CITY OF LAS VEGAS		DATE:
INTER-OFFICE MEMORANDUM		December 17, 2019
TO: Land Development Services Department of Building & Safety		FROM: Albert Sung, P.E. Flood Control Project Engineer Department of Public Works
SUBJECT:	Drainage Study for: PM 19-600023 (Project in Clark County for City of Las Vegas Concurrence)	
Cross Streets:	NWC of Lone Mountain Road & Valadez St.	Angel Diaz & Joan Kissling
File Number:	F:\Depot\DSMemos\DS5228A.doc	Bart Anderson, P.E., DevCo
Parcel Number:	125-33-805-008	CCPW
Zoning Action:	N/A	
FEMA Flood Zone	YES	NO X
Proposed Storm Drain	YES	NO X

Drainage Study Approval Letter

Subject: Technical Drainage Study for Diaz Kissling MSM 19-600023
Location: NWC of Lone Mountain Road & Valadez Street
APN: 125-33-805-008
Sec, Township, Range: S33, T19S, R60E
Flood Zone & Panel: Zone X, 2135F, dated November 16, 2011
Application Number: PW19-18375

**TECHNICAL DRAINAGE STUDY FOR
PM 19-600023
SECTION 33, TOWNSHIP 19 SOUTH, RANGE 60 EAST
CLARK COUNTY, NEVADA**

SHEET
C1.0
1 OF 4
PROJ. NO.
D151

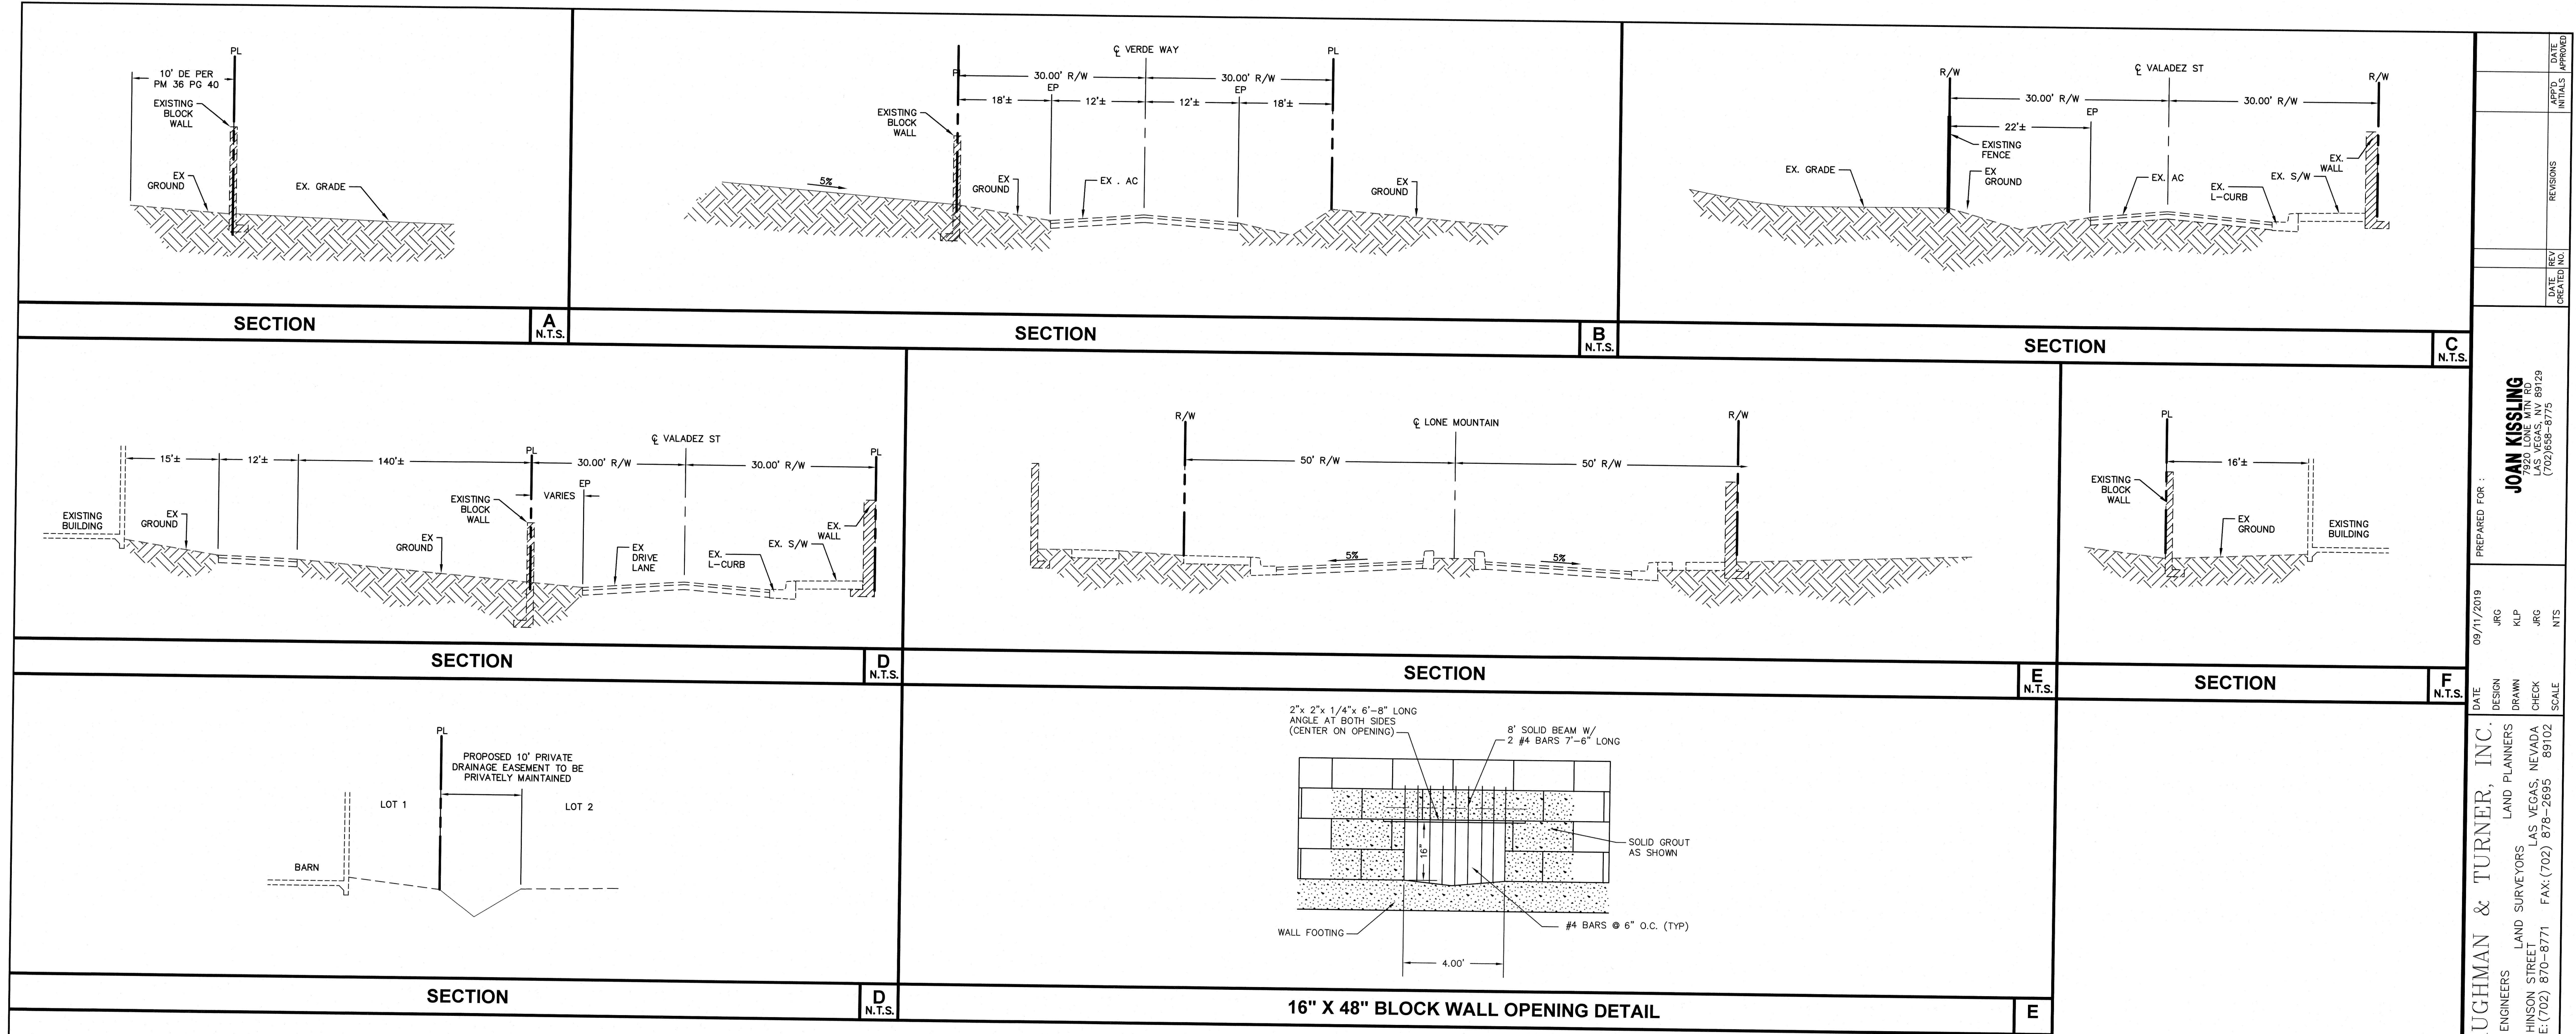
The site shall be graded with respect to drainage as shown on **"Diaz Kissling"** grading plan sheet C1.0 and C1.1, signed and sealed by John Gustafson, P.E., on October 7, 2019 and **"PM 19-600023"** grading plan sheet C2.0 and C2.1, signed and sealed by John Gustafson, P.E., on November 8, 2019.

C2.0

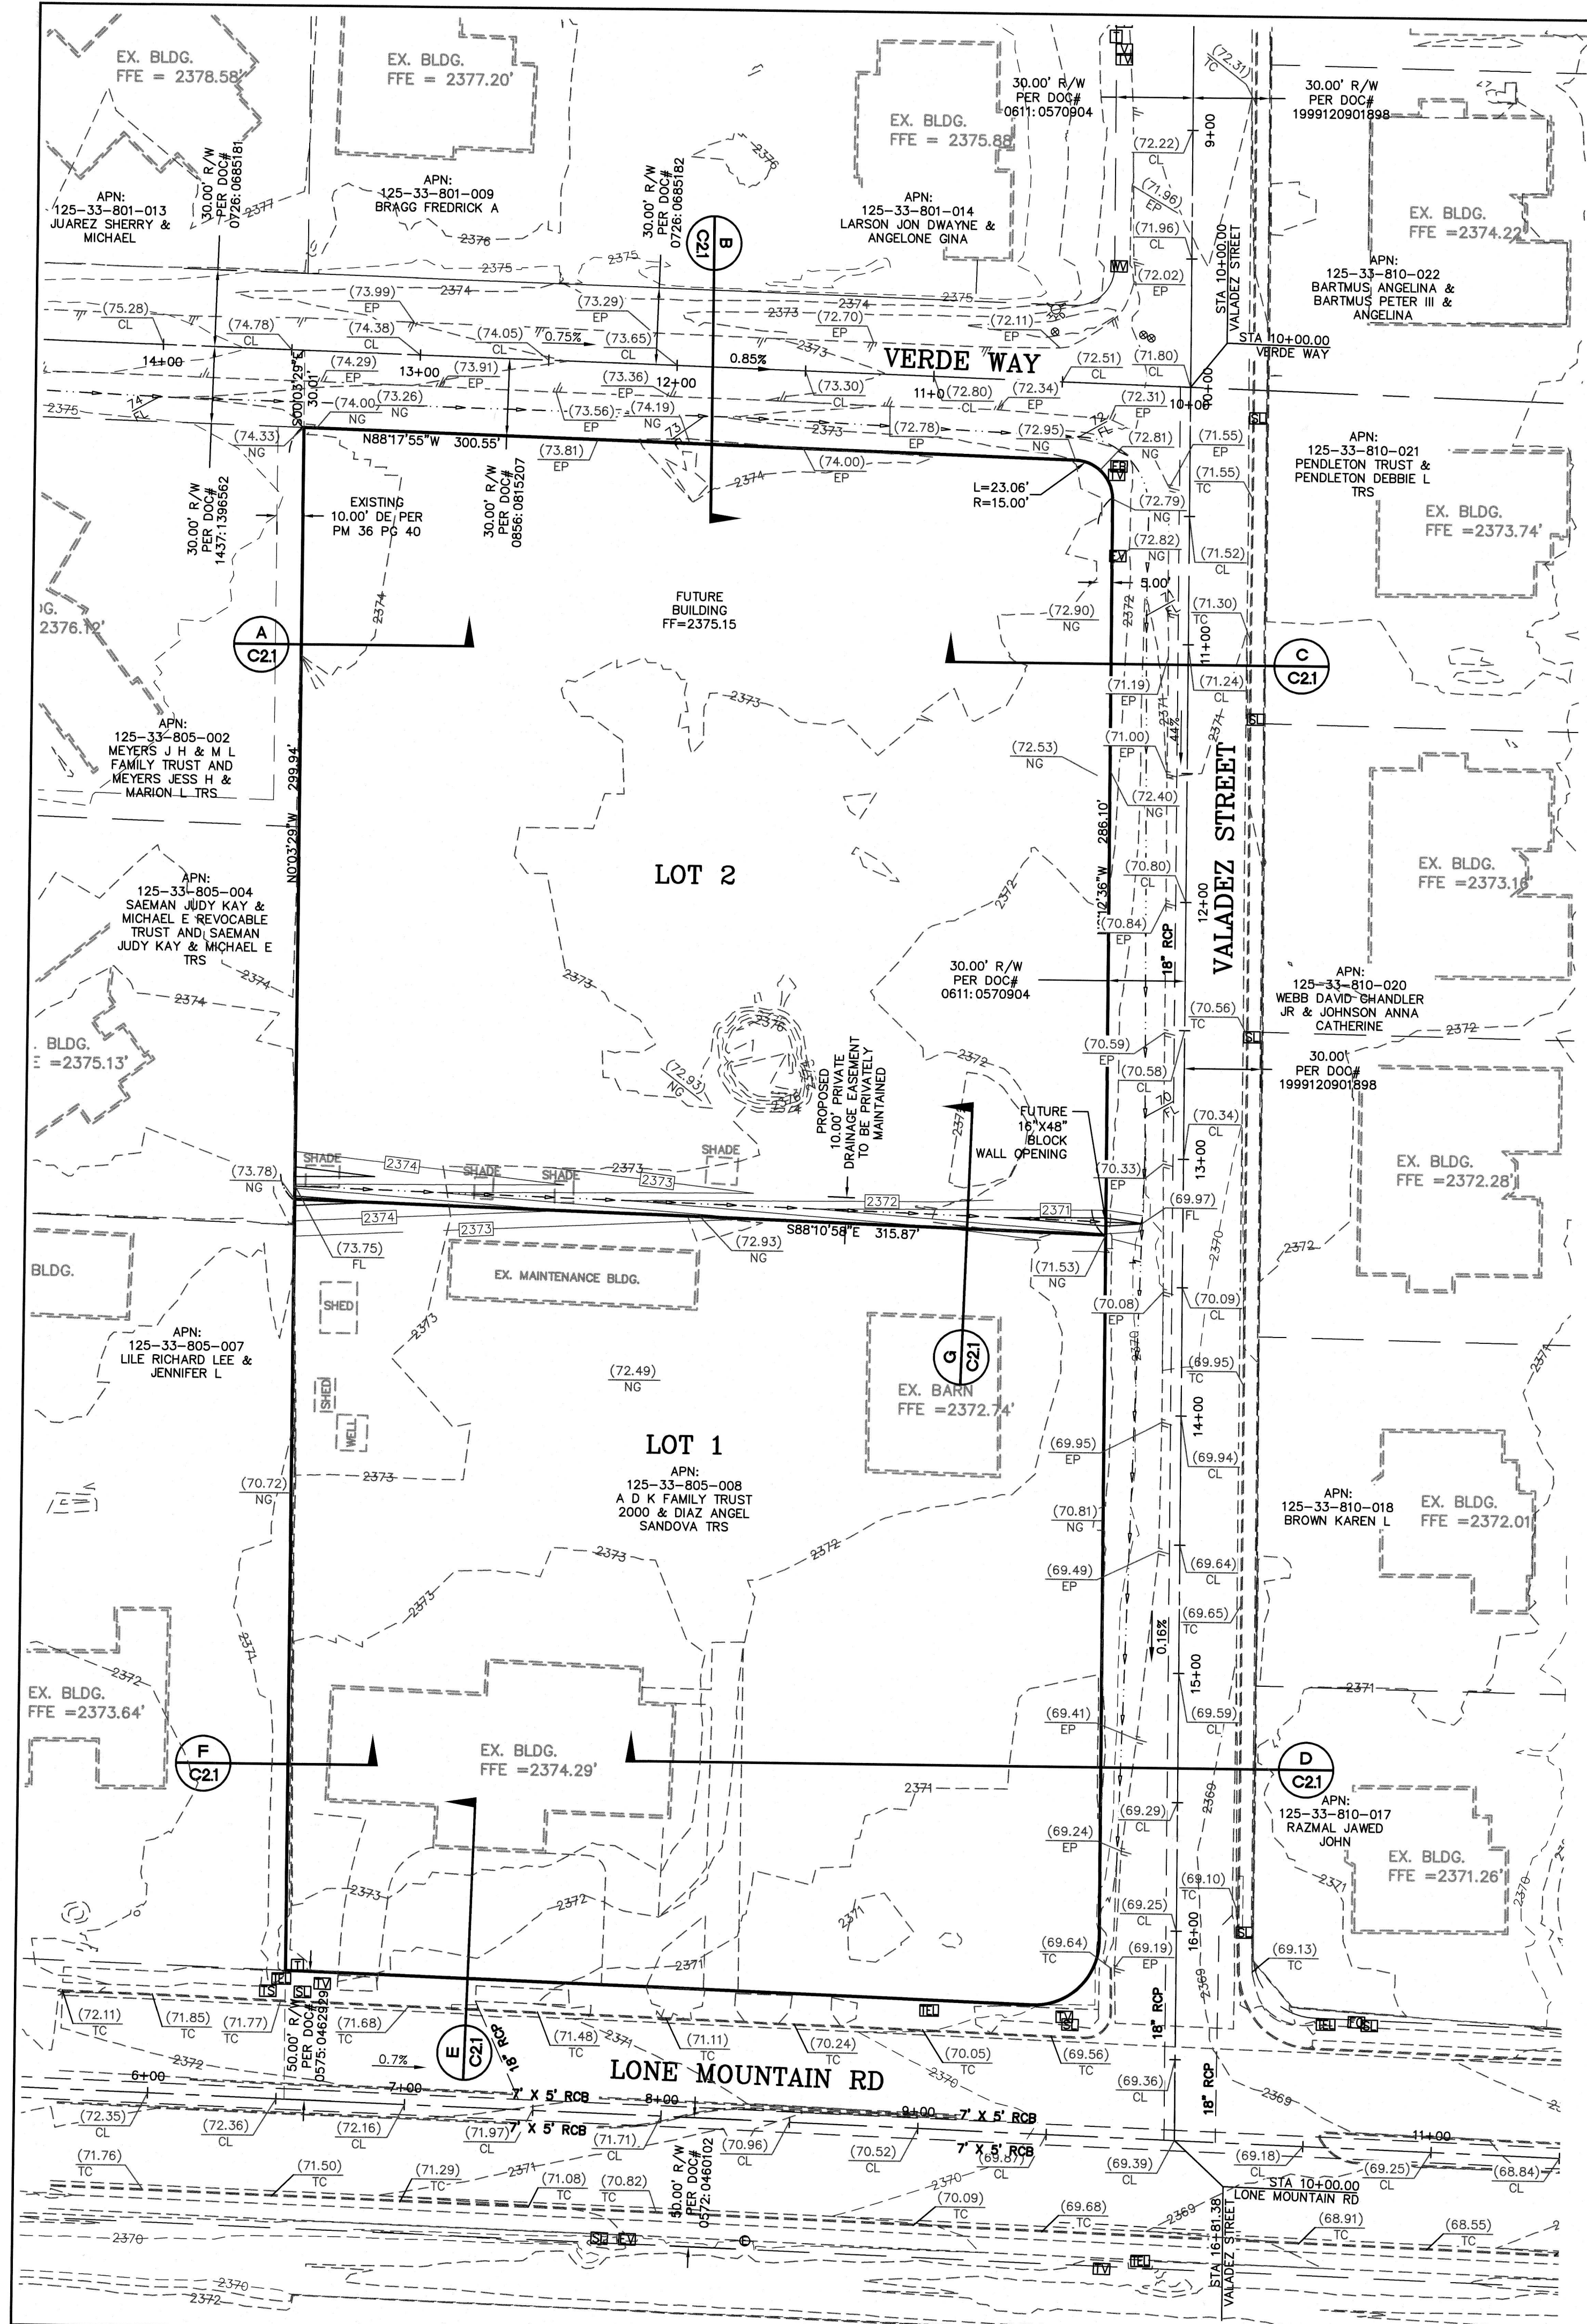
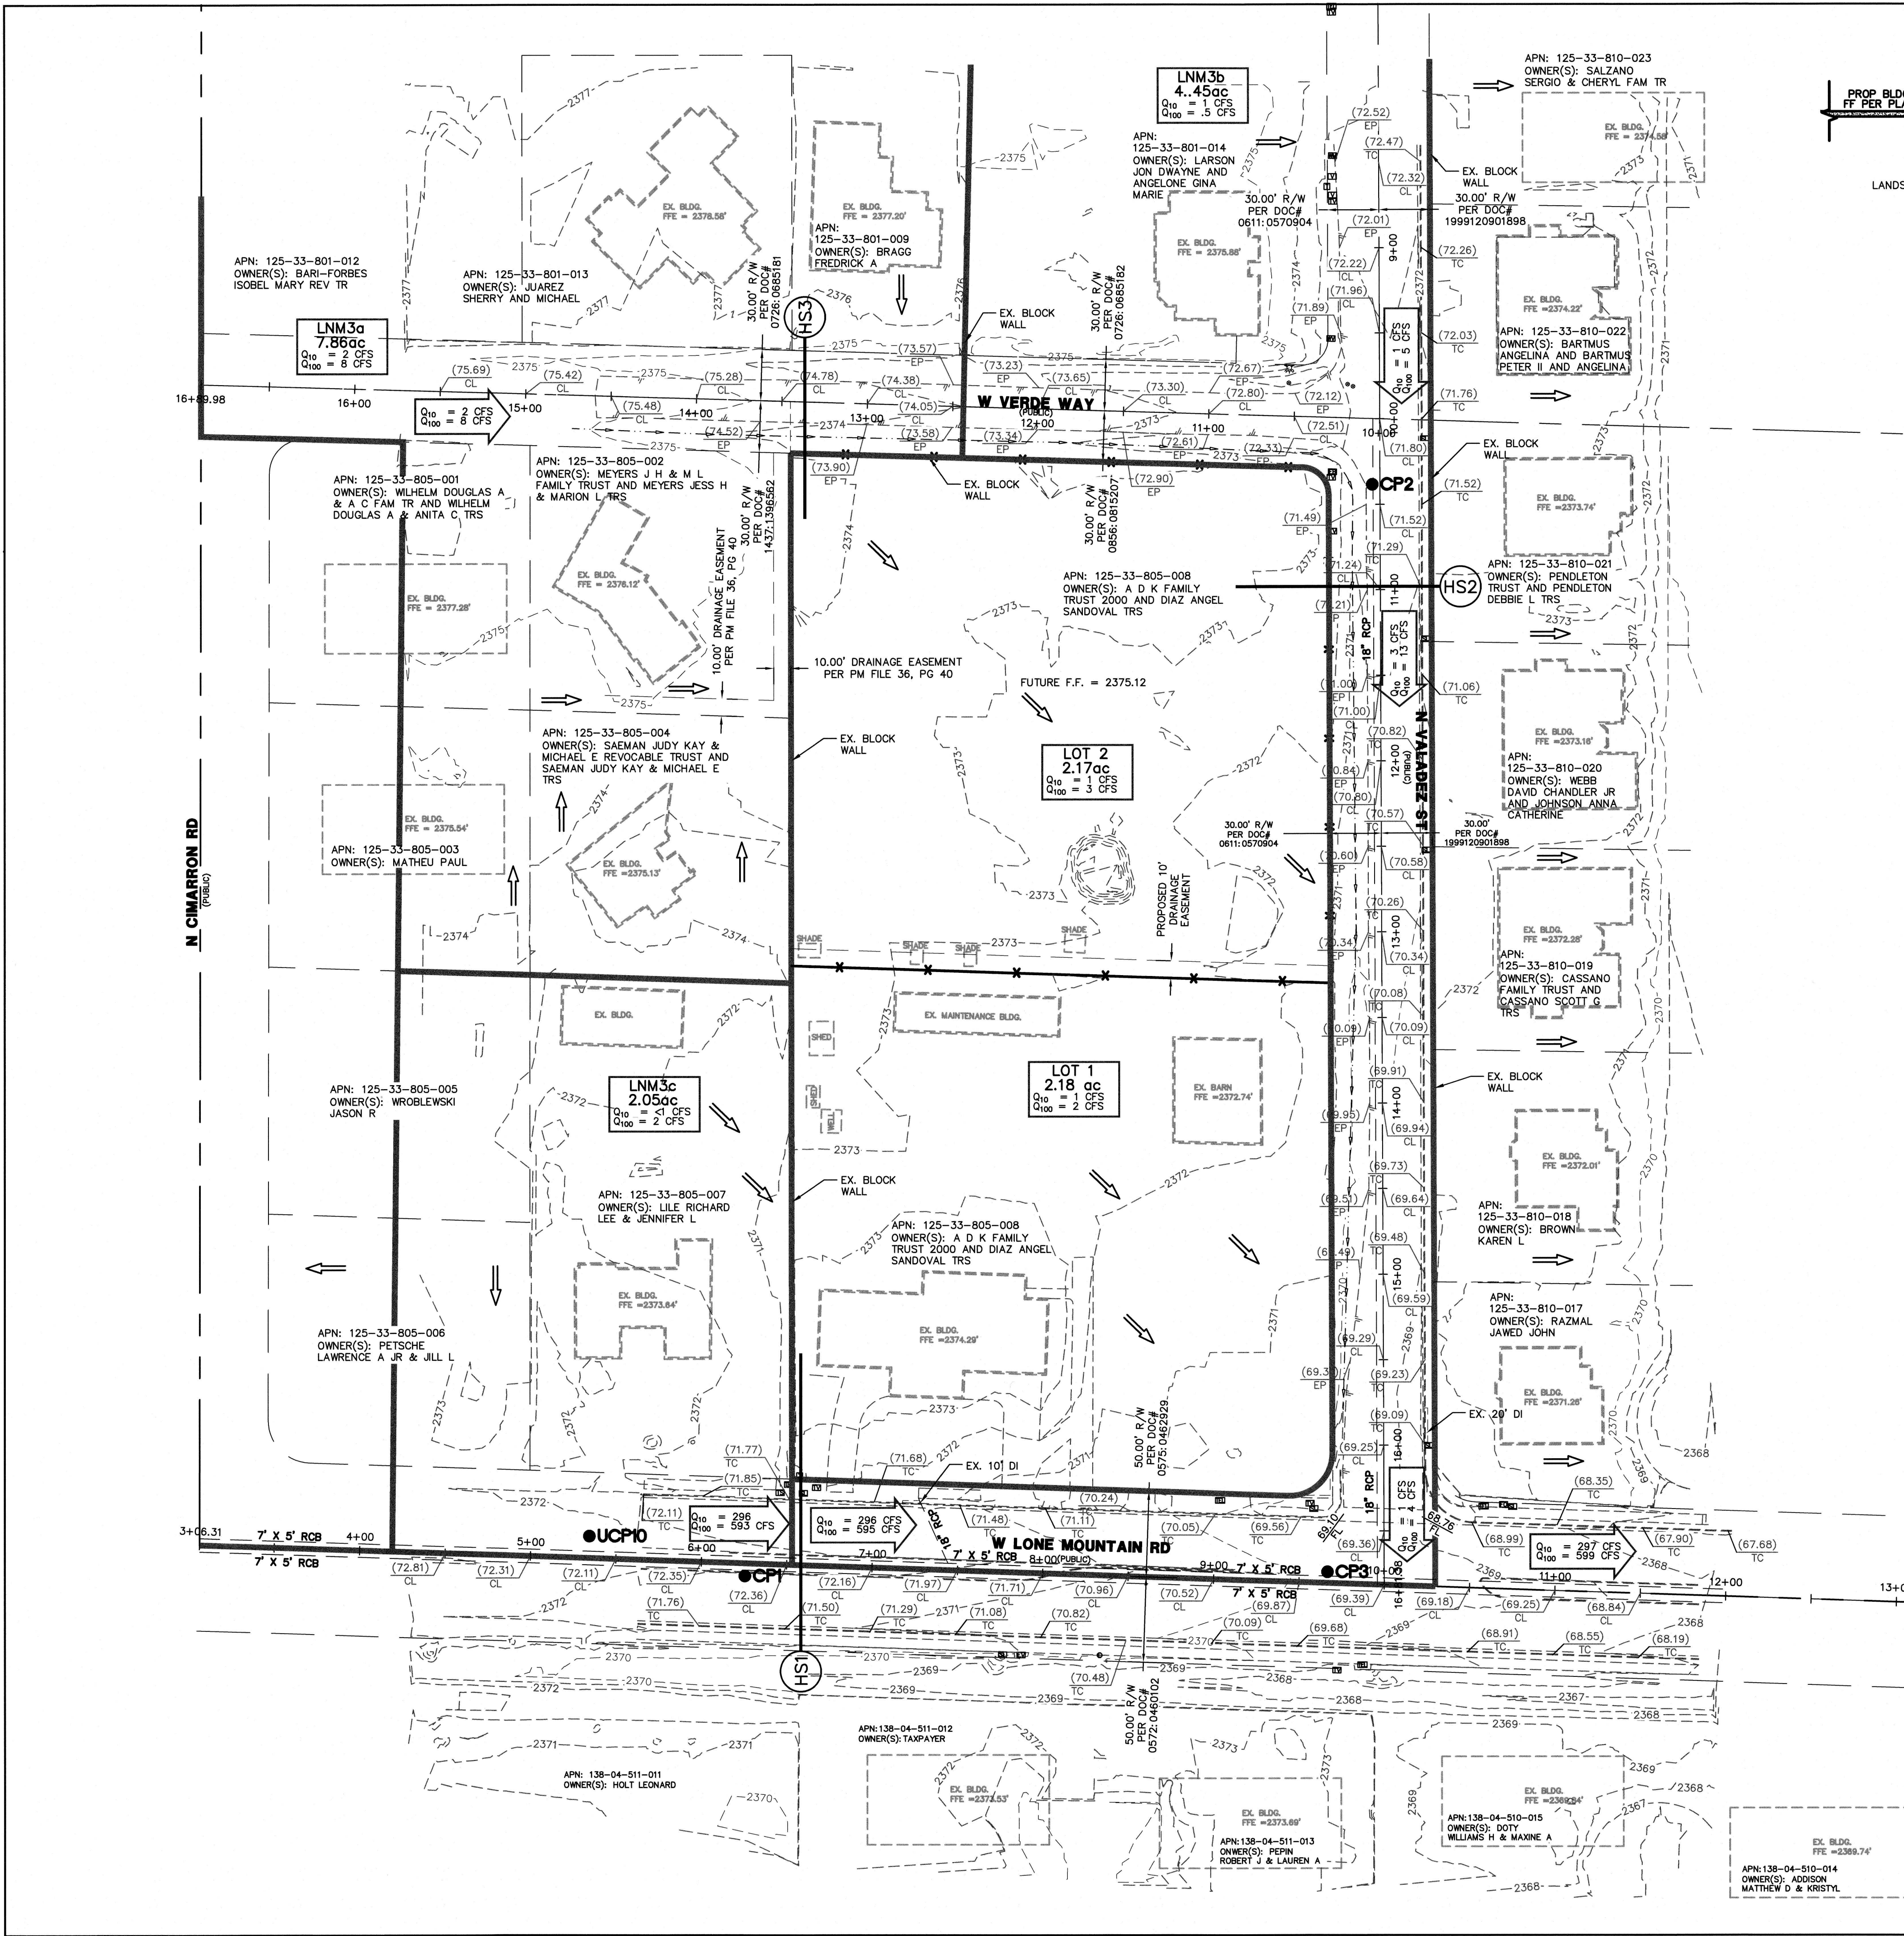
The plans show work is proposed on another property. Notarized written permission must be obtained prior to plan approval. A grading permit must be obtained from Building Dept prior to grading.
	Right-of-way dedication must be verified.
	Any previously approved drainage easements that are not being used must be vacated.
	Per <i>Regional Flood Control District policies and Procedures manual, Section VIII. D. 13. Uniform Regulations for the Control of Drainage</i> , the Engineer of Record shall provide As-Built plans or record drawings to the District after completion and final inspection of such privately installed flood control facilities that have regional flood control significance.
	Structural calculations are required. The structural calculations, plans, and details must be approved prior to "Offsite" submittal and prior to CCRFCD submittal, if applicable.
X	Plan revisions can be found on the red-lined plans and must be addressed.
